OAP7144

Opel & Vauxhall 1.4 Petrol

Fig. 1

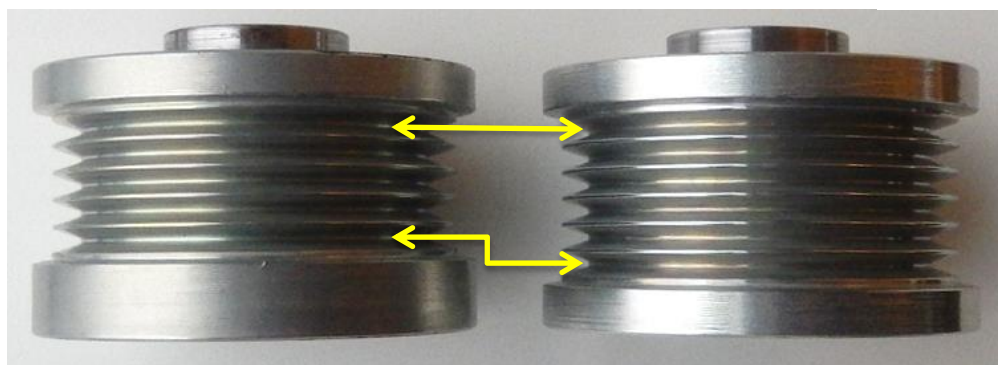
On certain Opel/Vauxhall engines (codes: A14NEL, A14NET, A14XEL, A14XER) the belts may have 5 or 6 ribs while the pulleys may have 5 or 6 grooves. It depends on the manufacturing date of the car. Gates recommends replacement of a 5 groove OAP (Fig.1 left side) with the 6-grooved OAP7144 (Fig. 1 right side).
